# SERVICE BULLETIN **Buell**<sup>®</sup>

B-024B

## SAFETY RECALL CODE 0817 - REVISED SHOCK EYE

Since the release of the original bulletin (B-024), Buell Motorcycle Company has released a **new** shock absorber. This revised recall procedure applies to affected motorcycles that did not have the initial 0817 recall service performed. For motorcycles that have had the original 0817 recall service performed, refer to Bulletin B-035 for installation instructions.

Figure 2. New Shock Absorber Assembly

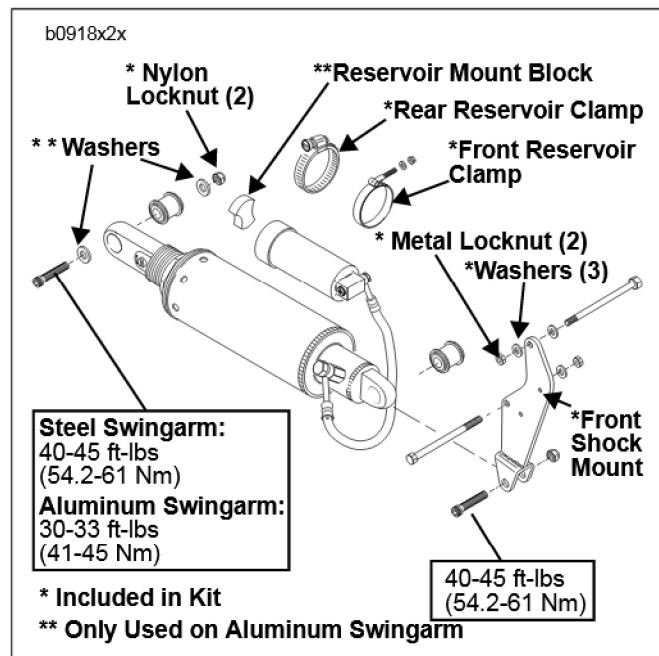
The new front shock mount **MUST** be used with the new shock absorber. The new shock is 1.77 in. (45 mm) shorter than the previous shocks and requires the new front mount to align and install properly.

1. See Figure 2. Install **new** front shock mount to crankcase with two **new** front shock mount bolts, washers, star washer (on 1997 M2, S3/S3T models only) and metal locknuts. Tighten bolts to 30-33 ft-lbs (41-45 Nm). **NOTE:** Top bolt goes in from the left side, bottom bolt goes in from right side. Bottom bolt does not use washer under bolt head. Star washer (only used on 1997 M2, S3/S3T models) goes on bottom bolt under the washer on the nut side. If exhaust was loosened during front shock mount removal, replace exhaust gaskets and reinstall exhaust. See appropriate Service Manual, Section 2 for instructions.

4. See Figure 2. Position **new** shock absorber from kit in mounting position.
5. Loosely install bolt, washers (aluminum swingarms only) and **new** locknut through rear shock eye and swing arm.
6. Loosely install bolt and **new** locknut through front shock eye and front shock mount.
7. **On 1996-1998 vehicles only:** Loosen header tie bar from collector.
8. Position front clamp over reservoir. Loosely install **new** front reservoir clamp to front shock mount (and install **new** header tie bar spacer between front shock mount and header tie bar on 1996-98 vehicles only) with **new** washer and **new** nylon locknut.
9. See Figure 3. Loosely install **new** rear clamp around reservoir and oil feed line.
10. **All Models:** Install **new** reservoir mount block between oil pump fitting and remote reservoir.

**Figure 4. Measuring Preload**

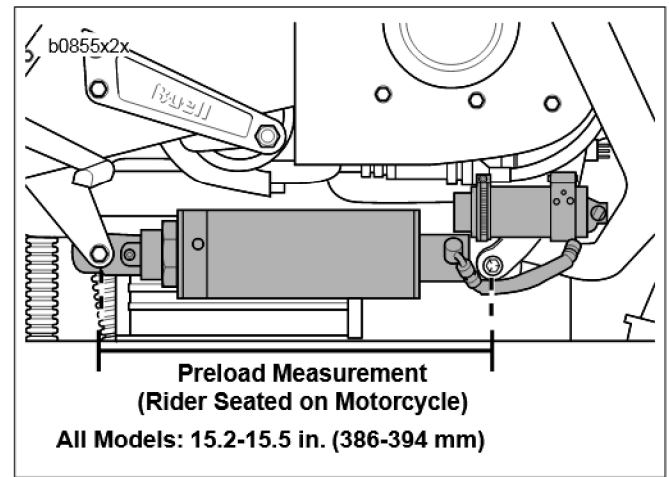
1. See Figure 4. Check and adjust rear shock preload.
  - a. With rider seated on motorcycle, the preload is determined by measuring the distance between the centers of the front and rear shock eye and adjusting until the measurement is within specification.
  - b. See below for optimum preload measurements:
    - **All Models:** 15.2-15.5 in. (386-394 mm)

**Figure 5. Preload and Compression Adjustments**

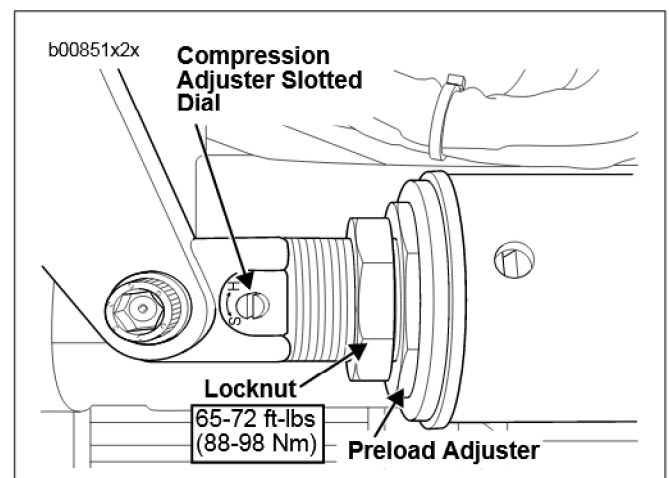
7. See Figure 5. Set compression damping using the slotted dial on the shaft at the end of the shock. New factory setting is as listed below:
    - **S1/S1W/M2 Models:** full damping minus 2.25 turns.

**Figure 6. Rebound Adjustment**

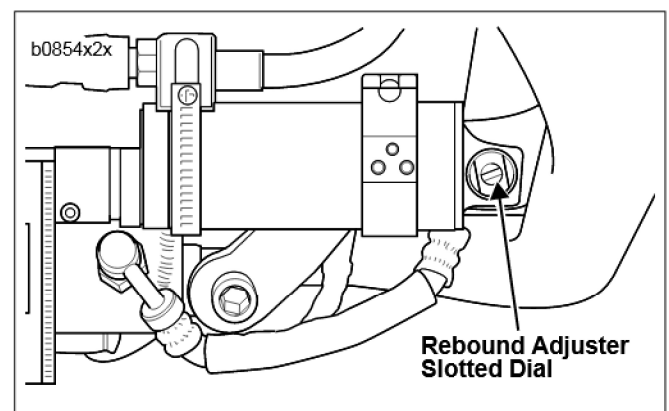
- **S2/S2T Models:** full damping minus 2.5 turns.
    - **S3/S3T Models:** full damping minus 2.5 turns.
  8. See Figure 6. Set rebound damping using the slotted dial on the remote reservoir at the front of the shock. New factory setting is as listed below:

- **S1/S1W/M2 Models:** full damping minus 1.5 turn.
    - **S2/S2T Models:** full damping minus 1 turn.
    - **S3/S3T Models:** full damping minus 1 turn.

Figure 7. Locknut Tightening Procedure

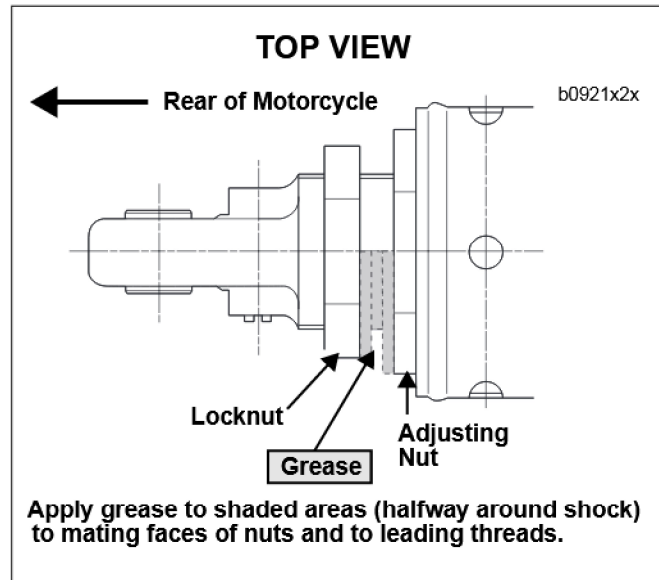
Since the release of the last bulletin (B-024A), the spring preload locknut tightening procedure has been modified (as covered in Bulletin B-037). This bulletin includes the new torque specification and tightening procedure.

5. Using SHOCK PRELOAD ADJUSTING TOOLS (Part No. B-45110), hold adjusting nut in place with 60 mm ADJUSTING NUT WRENCH and tighten locknut to 65-72 ft-lbs (88-98 Nm) with 52 mm LOCKNUT CROW'S FOOT set at 90 degrees to the torque wrench.
6. Wipe excess grease off of shock absorber.
